CONNECTION ASSESSMENT & APPROVAL PROCESS

PRELIMINARY ASSESSMENT REPORT: 3rd Addendum

*For the Proposed 600MW Portlands Energy Centre Project
by Ontario Power Generation Inc. at Hearn GS.*

CAA ID No. 2001-040

DIAGRAM 2

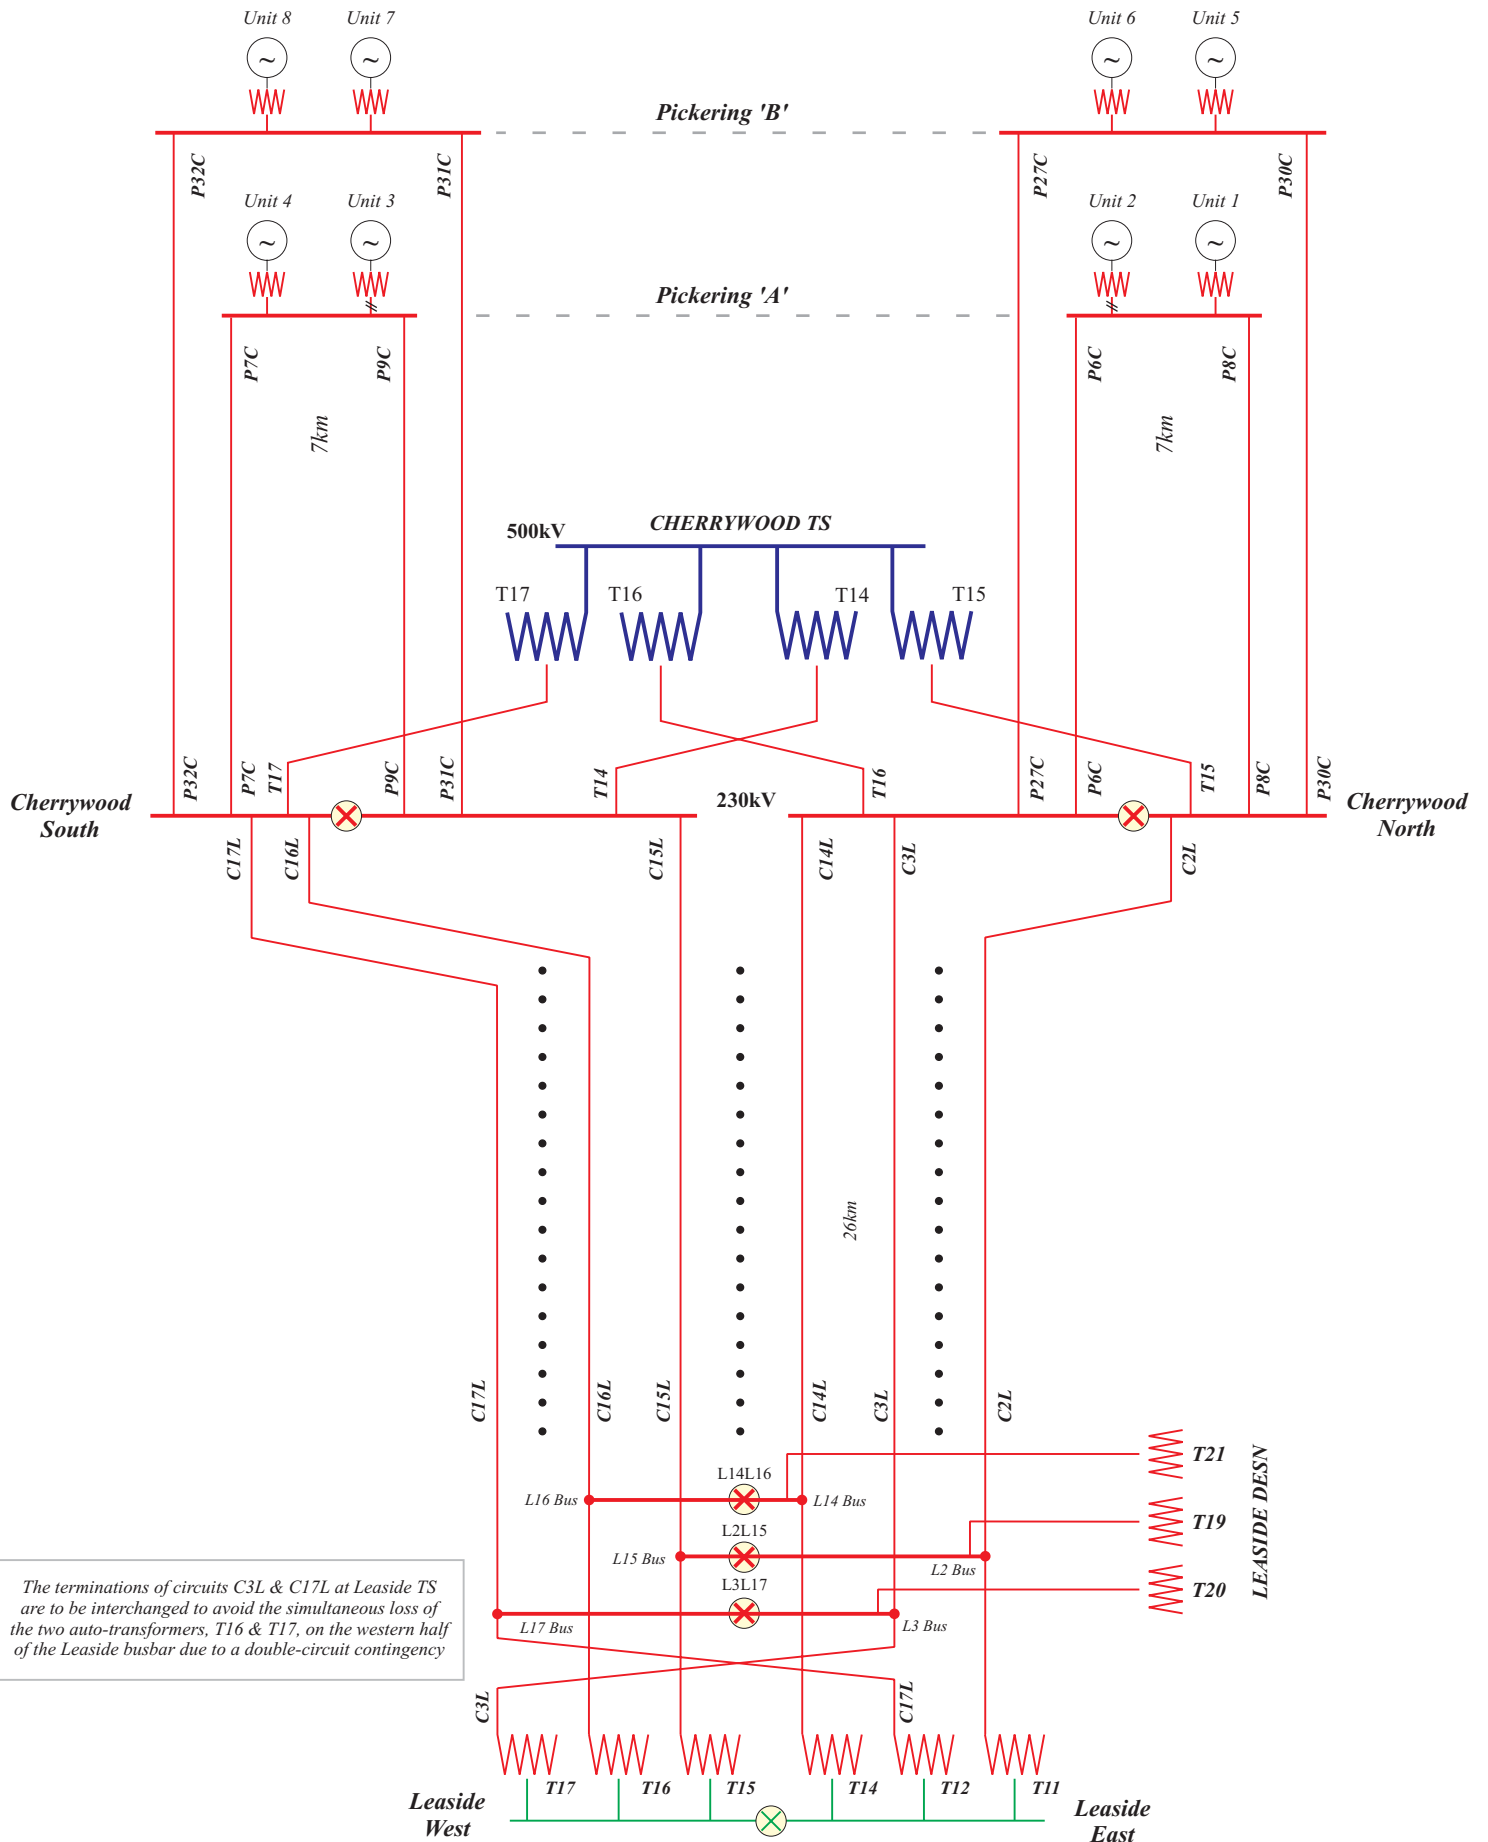
The arrangement that was selected for implementation is shown in Diagram 2. This would involve the interchange of circuits C3L & C17L between their respective connections to the 230kV bus-tie breaker L3L17 and their connections on to the auto-transformers T12 & T17. A contingency involving any of the three double-circuit lines between Cherrywood TS and Leaside TS would then result in the loss of only a single auto-transformer from each side of the Leaside busbar.

The terminations of circuits C3L & C17L at Leaside TS are to be interchanged to avoid the simultaneous loss of the two auto-transformers, T16 & T17, on the western half of the Leaside busbar due to a double-circuit contingency

- Defer the interchange of the 230kV circuits C3L & C17L until a permanent solution to the fault level issue can be implemented.
 - Temporarily remove one of the auto-transformers associated with the western half of the 115kV busbar at Leaside TS from service, pre-contingency, whenever high levels of generation capacity are dispatched.

DIAGRAM 12

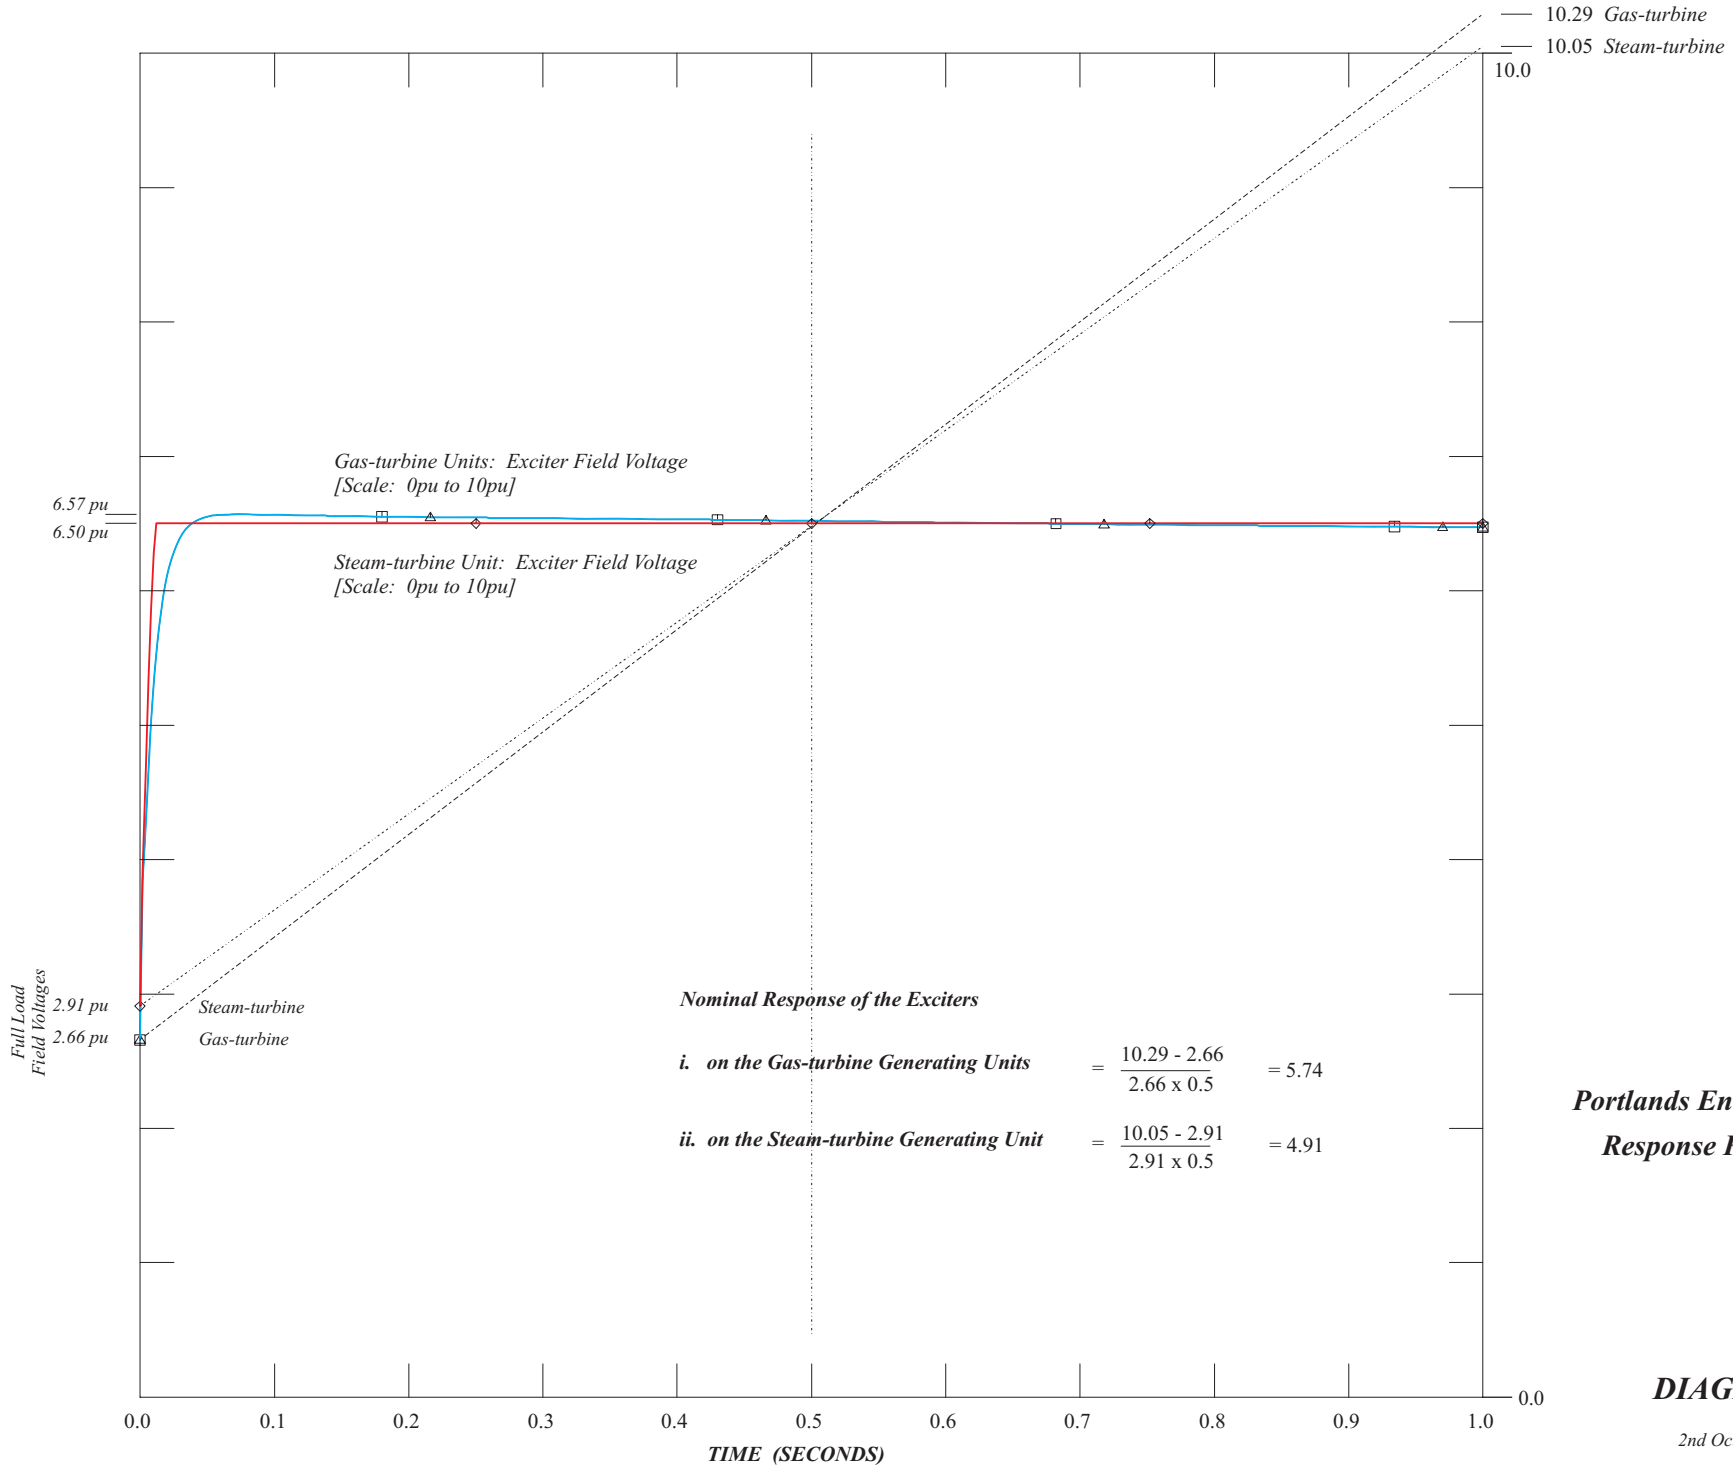
Diagram 12 shows the results for the initial 1.0-second period of the response ratio test for a large increase in the reference set points for the voltage regulators.

This shows that in response to the imposed change in the reference settings the exciter field voltages would increase by the following amounts from their full load values to their ceiling voltages:

- for the steam-turbine exciters: an increase from 2.91pu to 6.50pu equivalent to 223%
- for the gas-turbine exciters: an increase from 2.66pu to 6.57pu equivalent to 247%

- for the exciters on the gas-turbine units: a response ratio of 5.7
- for the exciters on the steam-turbine units: a response ratio of 4.9

**Portlands Energy Centre
Open-Circuit Step-Response**

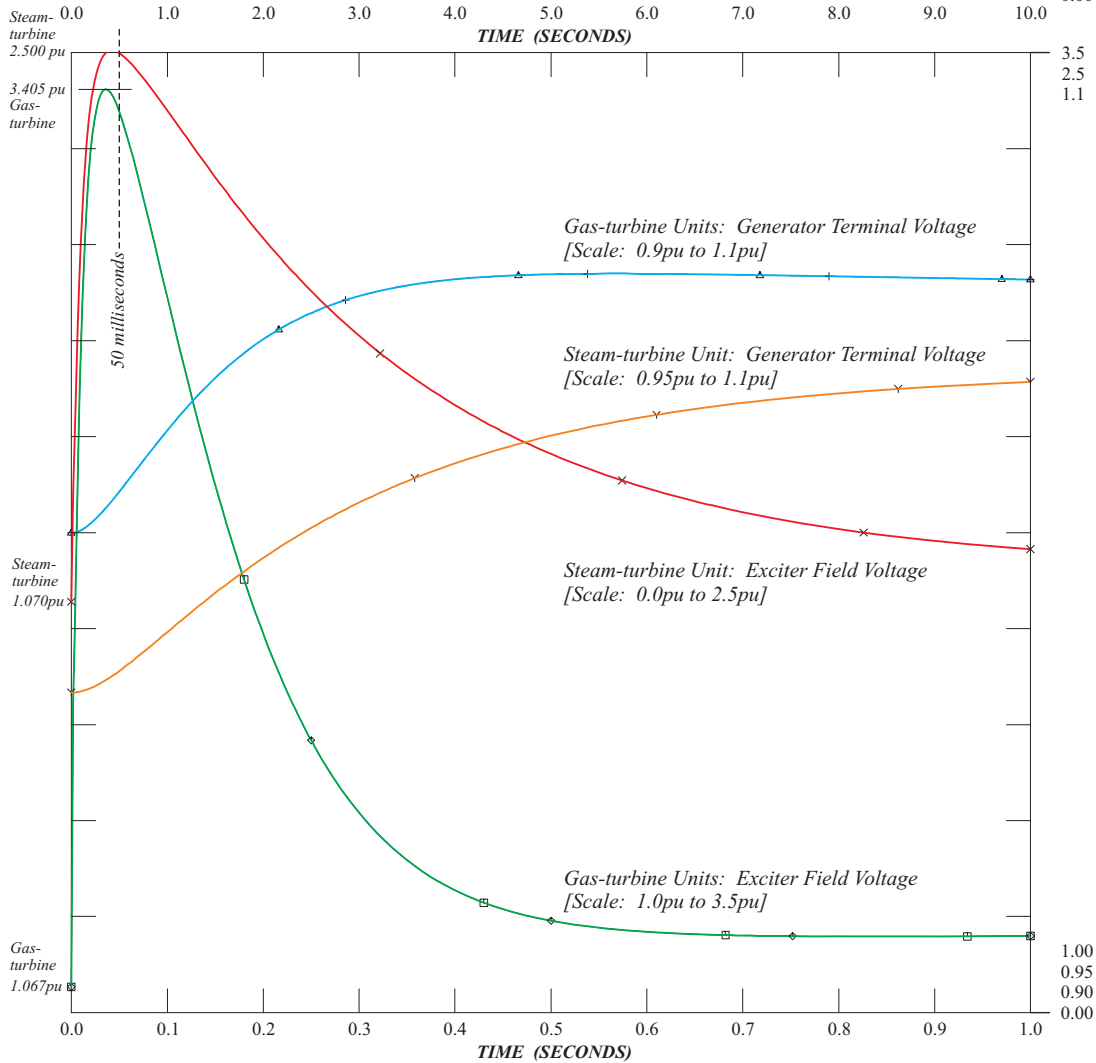
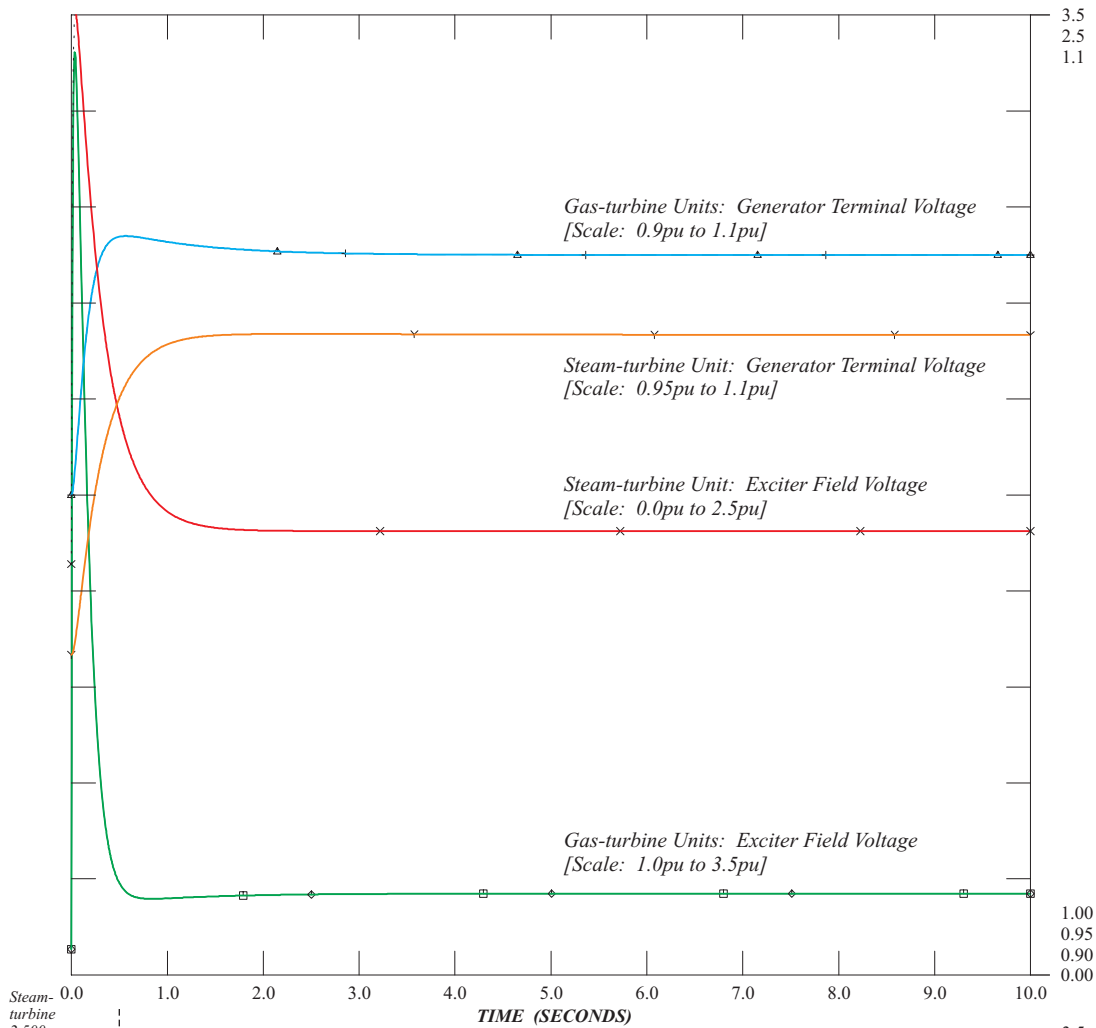
This shows that the exciter of the steam-turbine unit will reach a maximum voltage of 2.50pu within 50-milliseconds, while the exciters on the gas-turbine units will reach a maximum voltage of 3.40pu.

Diagram 13 shows that the exciters on the gas-turbine & the steam-turbine units are able to achieve a ceiling voltage of at least twice the rated field voltage as required by the Market Rules.

In Diagram 13, since the initial outputs from the exciters of all three generating units are shown as 1.07pu, then the minimum values that the exciter voltages are required to achieve within 50 milliseconds, following a 5% increase in the generator terminal voltage, will be as follows:

- for the exciter on the steam-turbine unit an output voltage of at least: 3.60pu.
- for the exciters on the gas-turbine units an output voltage of at least: 3.83pu

Diagram 13 shows that the maximum voltage that the exciters on the steam-turbine & the gas-turbine units would be able to achieve would be only 2.50pu and 3.40pu, respectively. The settings that have been proposed for the exciters would therefore not satisfy the Market Rules.

- iv. The settings proposed for the exciters on all three generating units have been shown to be inadequate to satisfy the requirements specified Market Rules. The IESO therefore requires revised settings to be implemented that will ensure compliance.

DIAGRAM 14

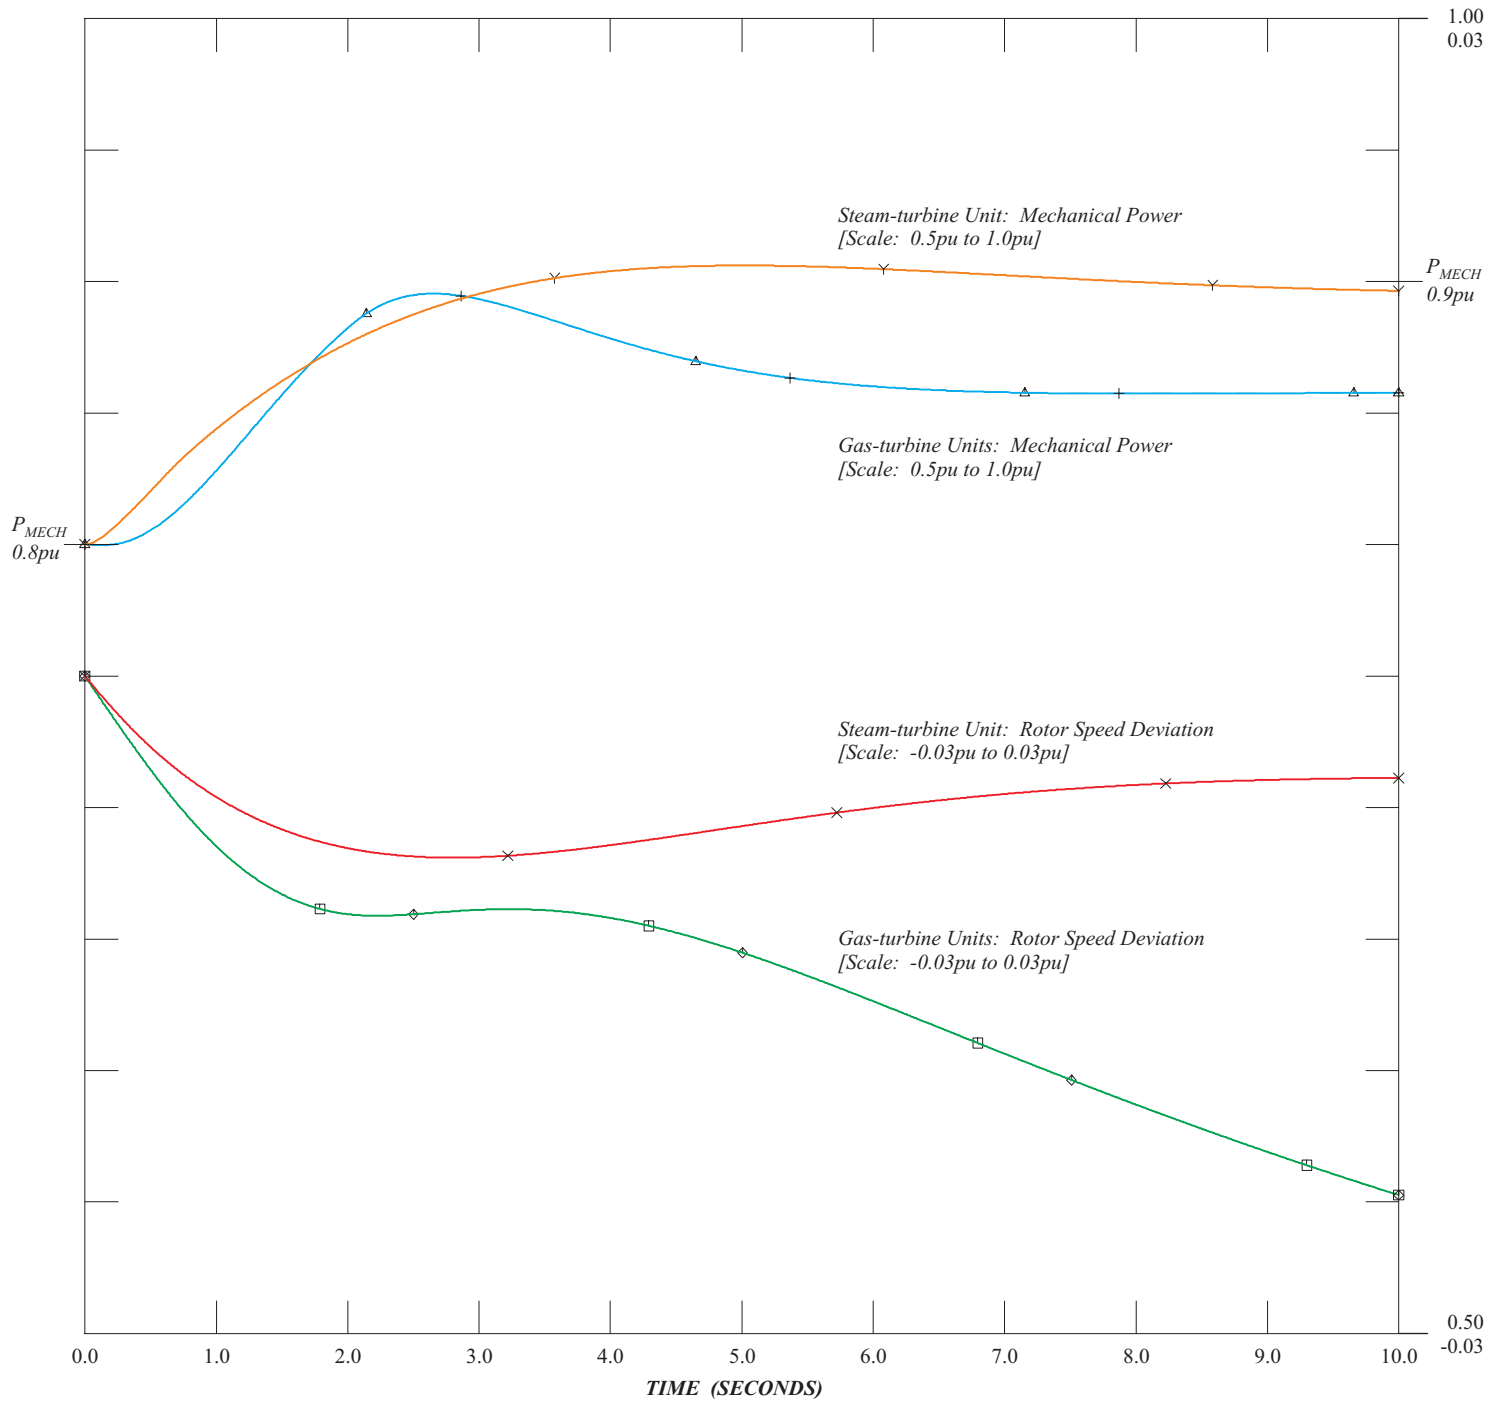
Diagram 14 shows the response of the individual governors to a 0.1pu change in the mechanical loading on the turbines.
